Office Action Summary

10/725,598

IRIKURA, KOJI

- 1) ☒ Responsive to communication(s) filed on 04 October 2005.
- 2a) ☒ This action is **FINAL**. 2b) ☐ This action is non-final.
- 3) ☐ Since this application is in condition for allowance except for formal matters, prosecution as to the merits is closed in accordance with the practice under *Ex parte Quayle*, 1935 C.D. 11, 453 O.G. 213.

Alden teaches a bull gear of a differential gear assembly (see Fig. 1), comprising:

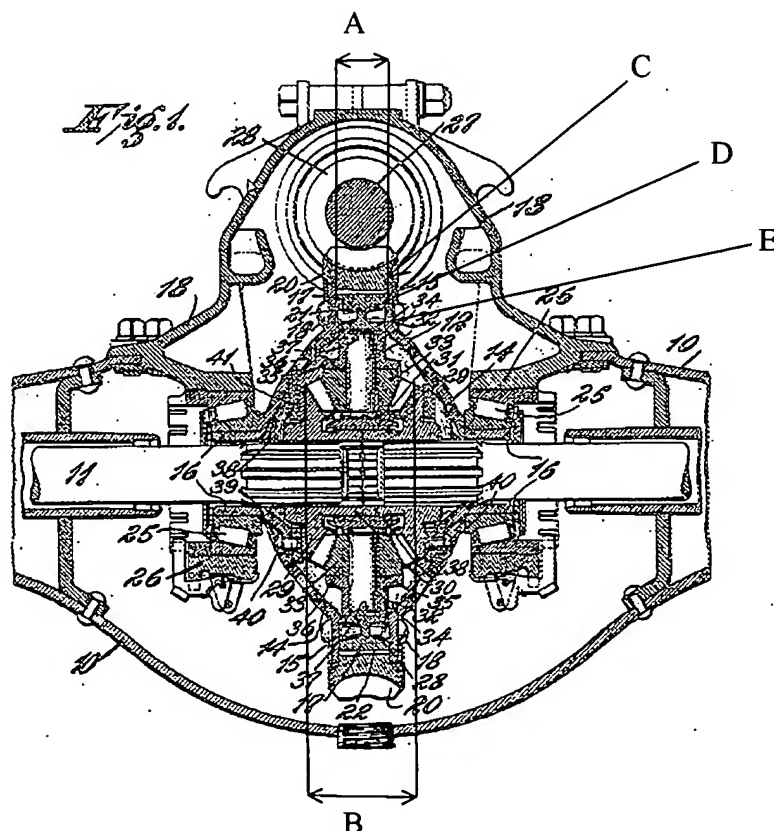
5. Claims 1, 6 and 10 rejected under 35 U.S.C. 102(b) as being anticipated by Alden (US 1,445,865).

a ring gear 20 for inputting torque from a transmission (see page 2, line 40), said ring gear having inner peripheral teeth 21; and

a plate-like shaped support member 17 having a rotary axis (the axis of shaft 11) and rotatably supporting a differential pinion 33 perpendicular to the rotary axis and relatively rotatably disposed on an axle 11, wherein the rotary axis of the support member is perpendicular to a rotary axis of the differential pinion and coincides with a rotary axis of the axle, wherein the support member has a thickness A (see the inserted Figure 1 below) that is smaller than the maximum diameter B of the differential pinion, and has opposite opened side surfaces from which the differential pinion partly projects outward, and wherein the support member has outer peripheral teeth 22, which relatively axially slidably and not relatively rotatably mesh with the inner peripheral teeth of the ring gear so as to transmit the torque from the ring gear to the axle through the differential pinion.

Regarding claim 6, the ring gear 20 having a toothed outer periphery and a toothed inner periphery, wherein the toothed outer periphery serves as an input gear for receiving torque from the transmission, and wherein the toothed inner periphery meshes with the toothed portion 22 of the support member 17 so as to couple the ring gear with the support member.

Regarding claim 10, the ring gear having 20 a first surface C perpendicular to the axle, and the support member having a second surface D to be leveled with the first surface of the ring gear, further comprising: a retaining member E abutting against the first and second surfaces so as to prevent the ring gear and the support member from relatively axial shifting.
